REQUEST FOR INFORMATION **DATE:** June 03, 2016 **NO.:** RFI-151

Project Name: 15051-Webster University Interdisciplinary Science
Building

Subject: Exterior Frame Details

1 PLAN DETAIL - EAST PROJECTED CURTAINWALL-JAMB
3" = 1'-0"

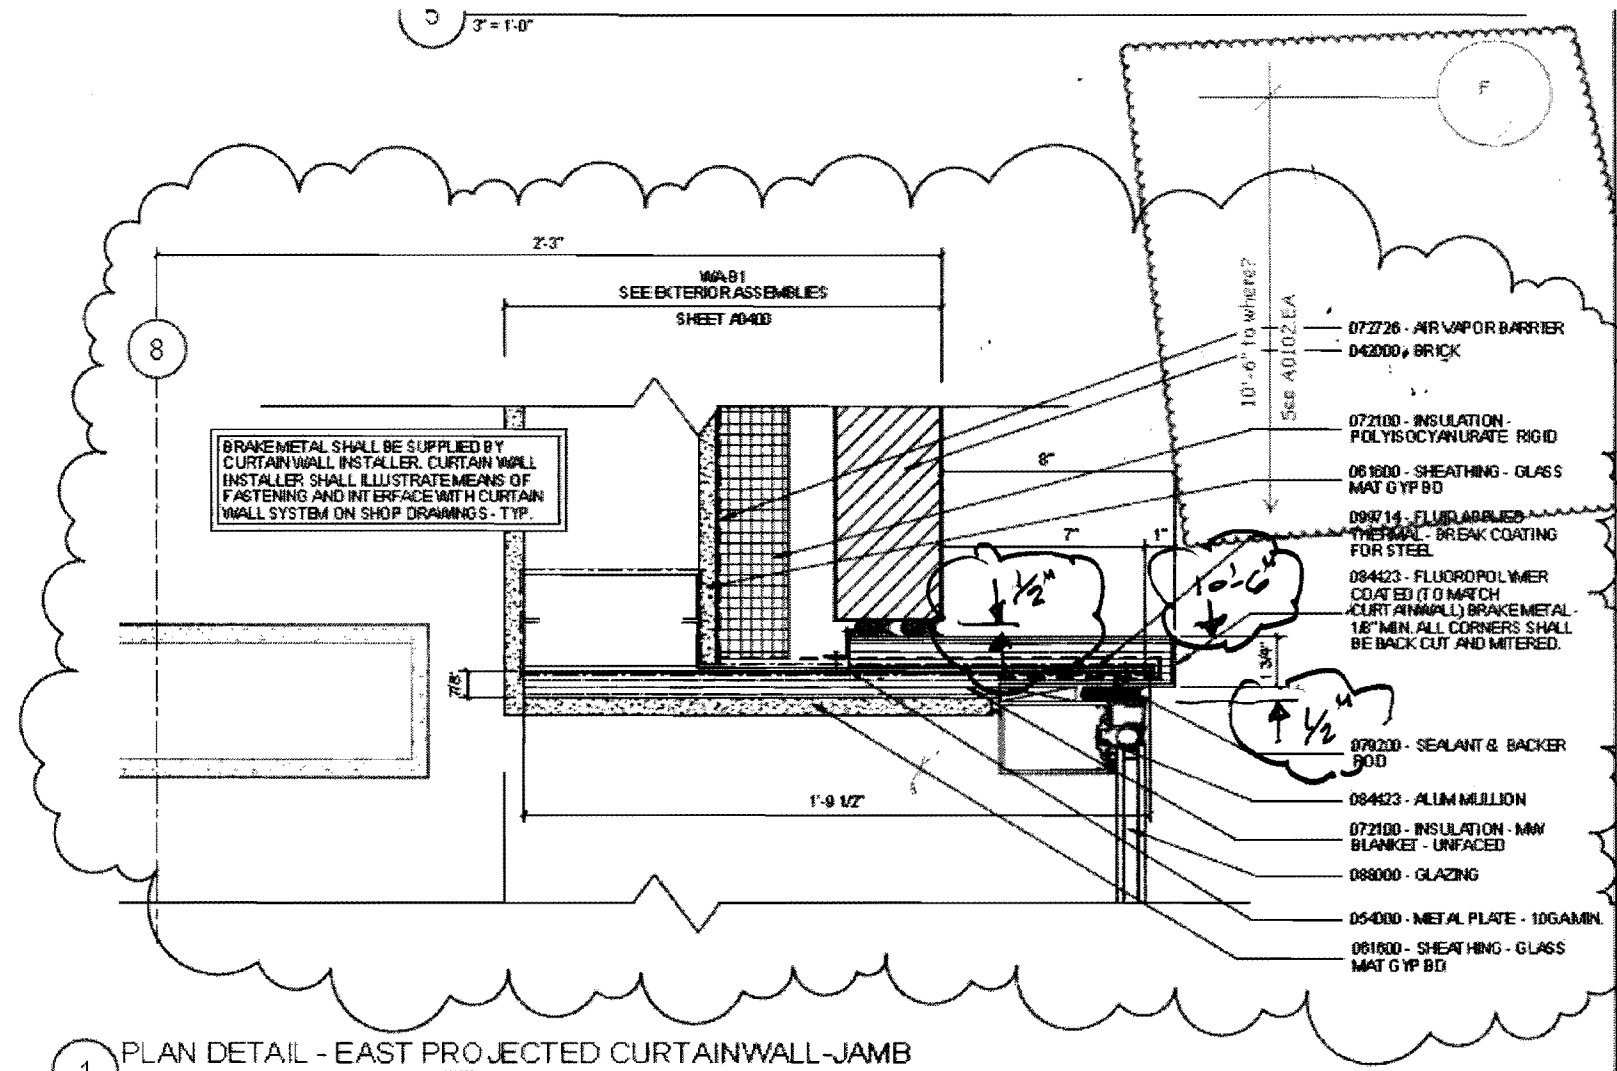
Please see attached. We are trying to figure out the exterior 'frames' on the building...

Response: The 10'6" dimension in question is indicated on Detail 1, Sheet A0422, as the North face of the 1¾" brake metal extrusion. See attached Sheet A0422.
